SOMERSET MASTER PLAN

ADDRESS : 2037 SW Red Barn Lane, Lees Summit, MO
LOT : HF 77

Revision/Change Log:

A802

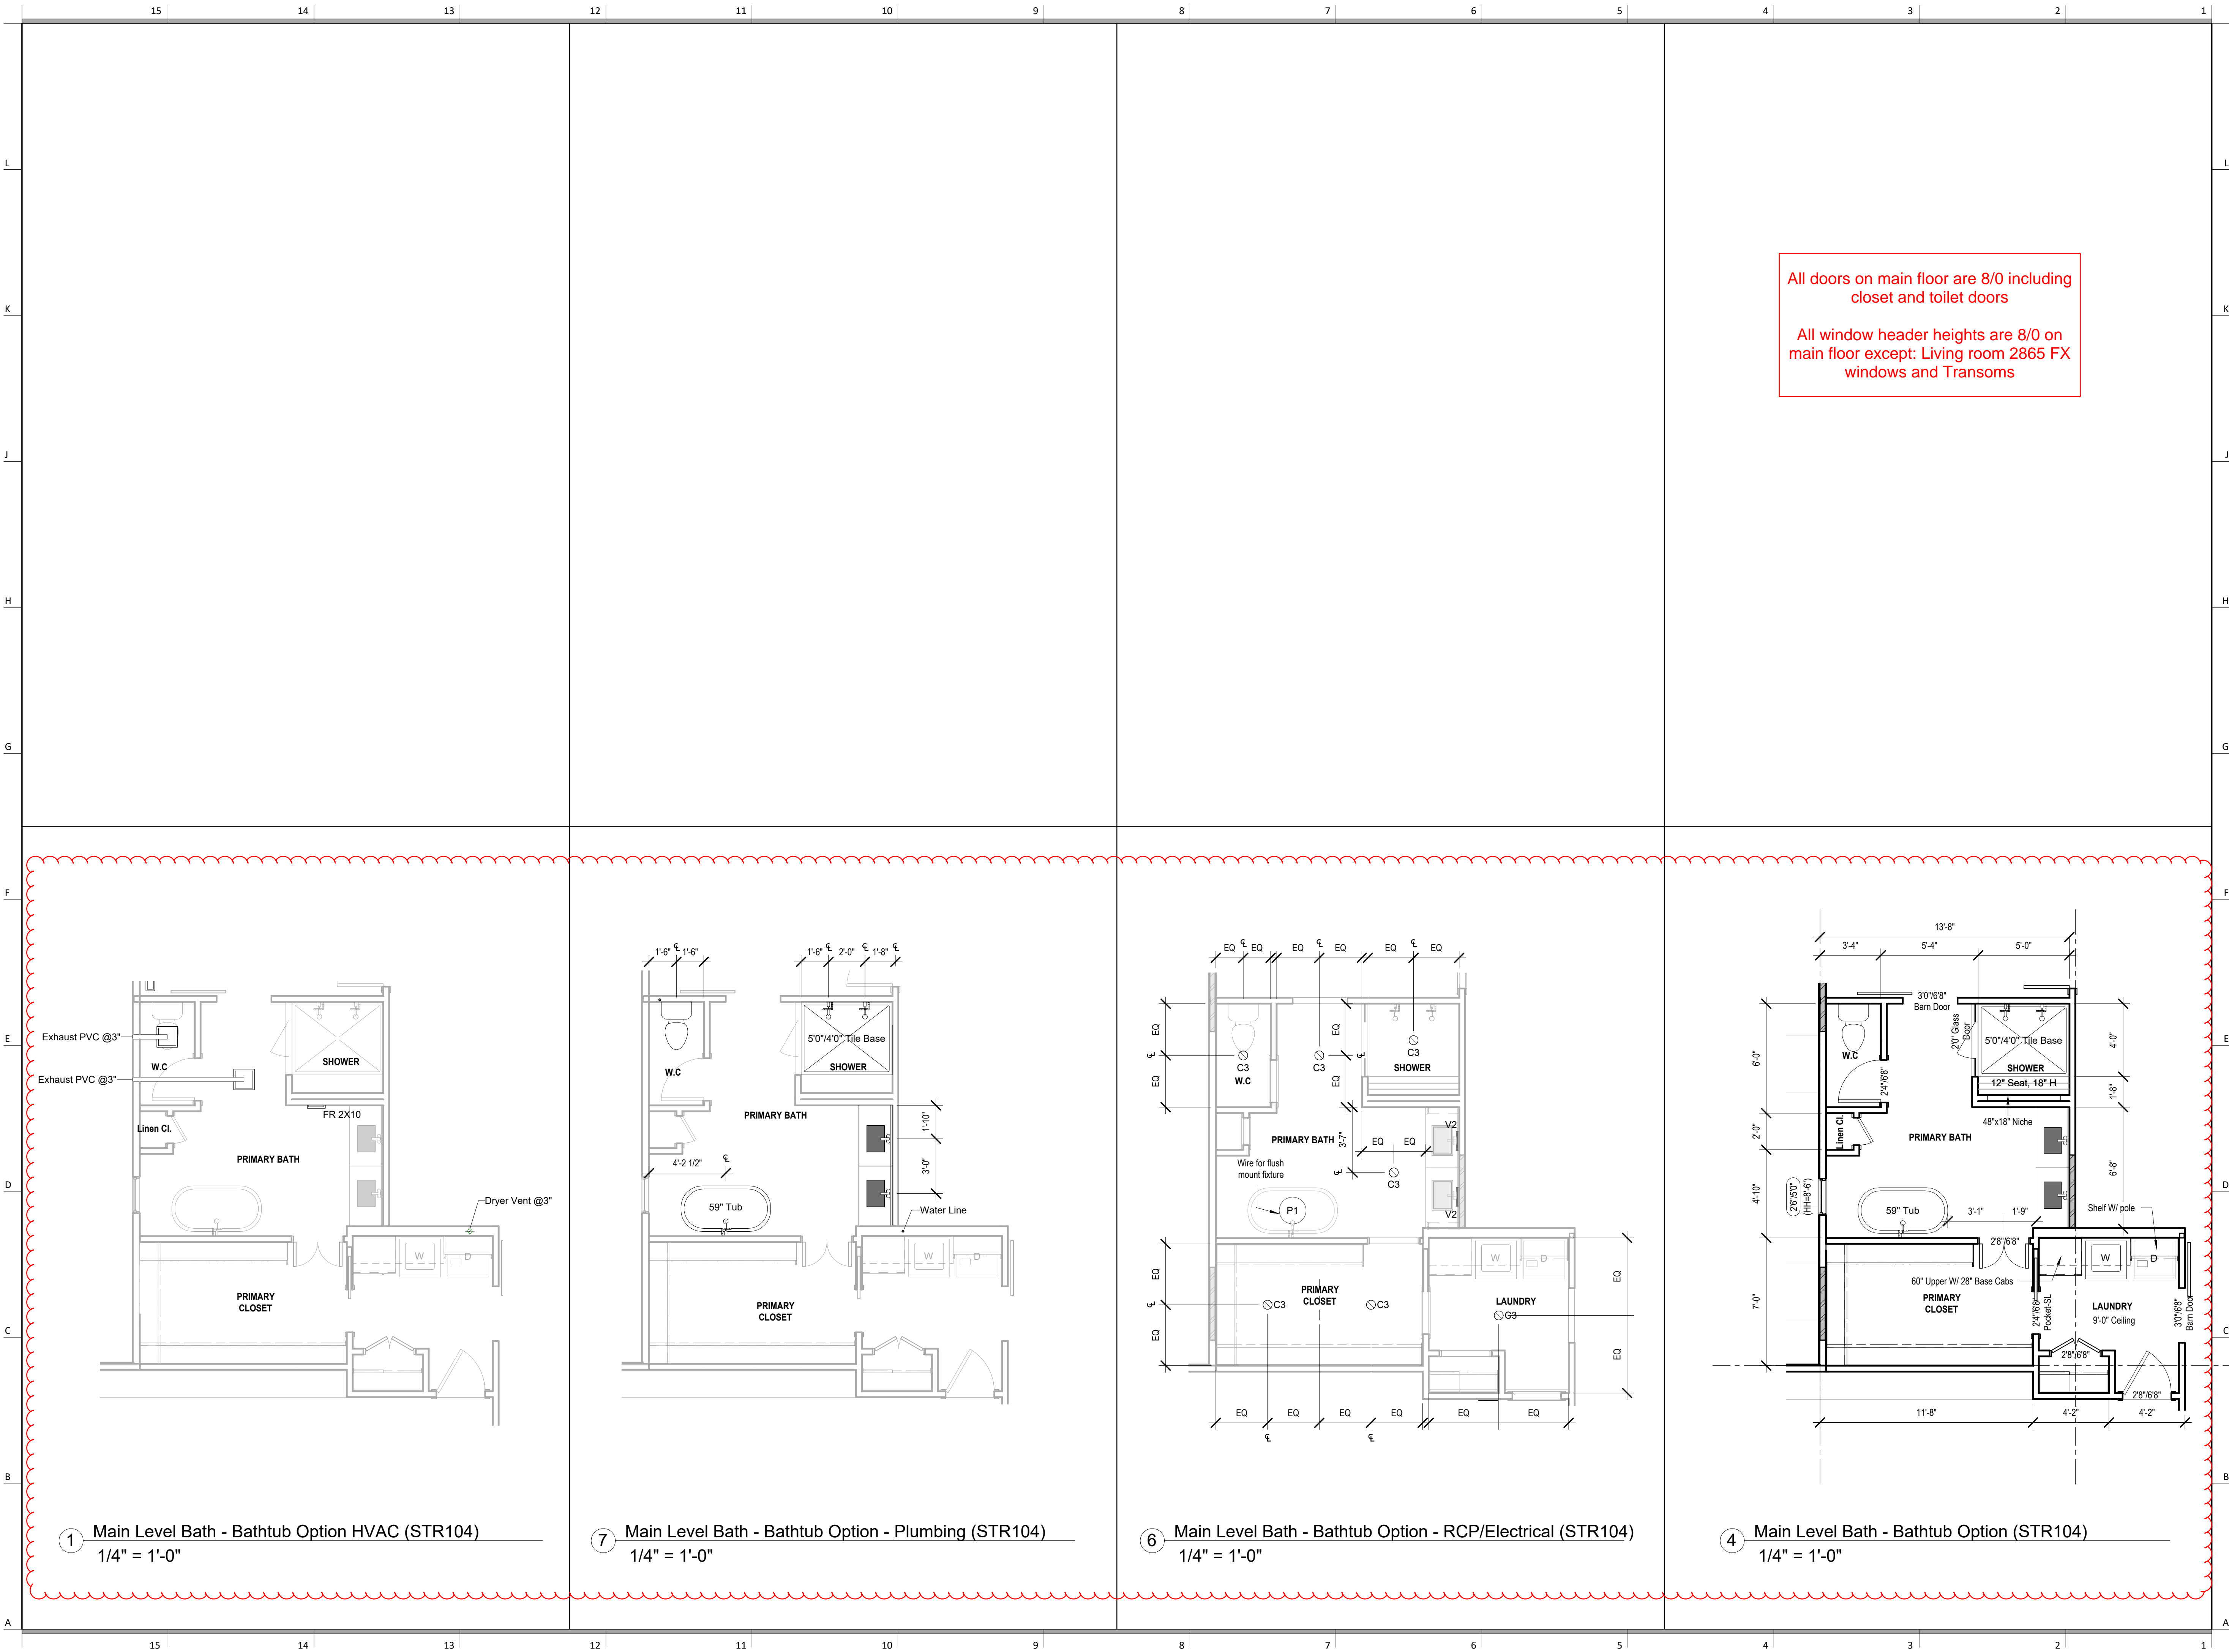
1. The correct Beam end position has been marked on foundation plan.
2. Changed the door to WIC from primary bath to double 2/6.
3. Changed the door to office on main floor to a double 2/6.
4. Removed the dropped mudroom, and updated the laundry/mudroom layout on A802 - removed page A807 W/ old dropped mudroom and laundry details.

A804

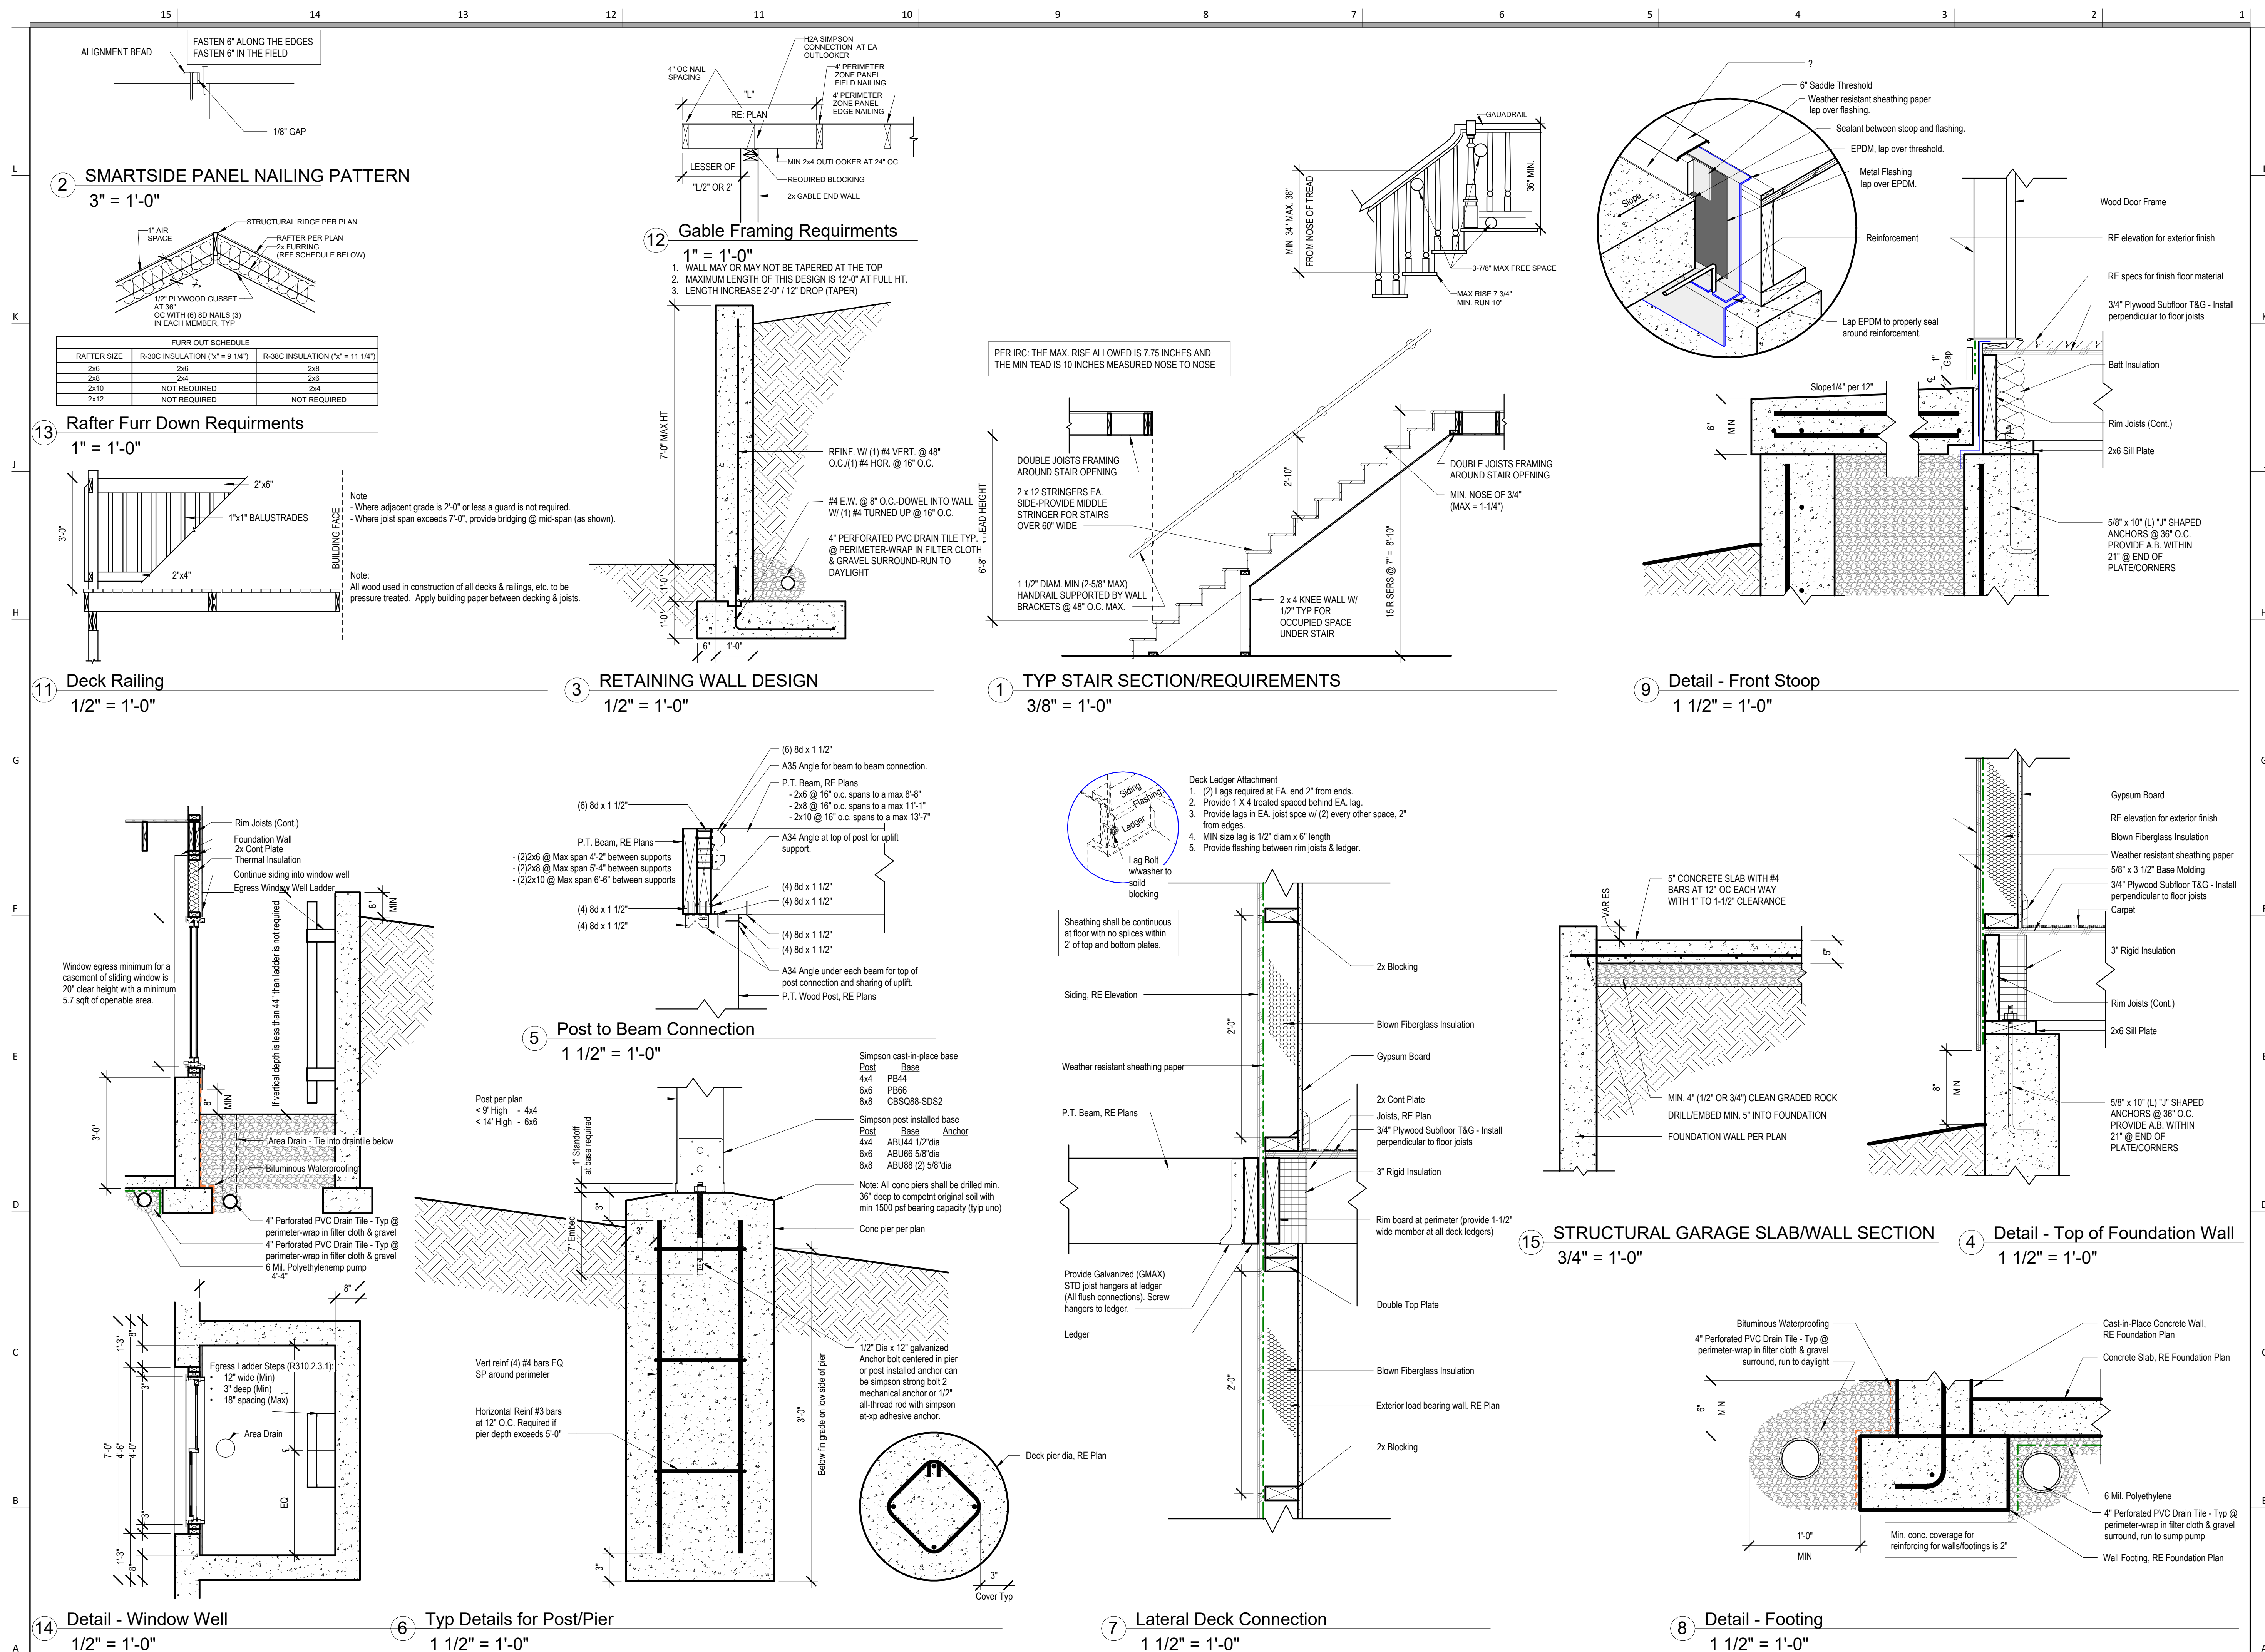
1. Added "EGRESS" label to primary bedroom windows on page A801.
2. Added SD and C/S outside Bedroom 2.
3. Confirming the East side window well is on plans, refer page A804.
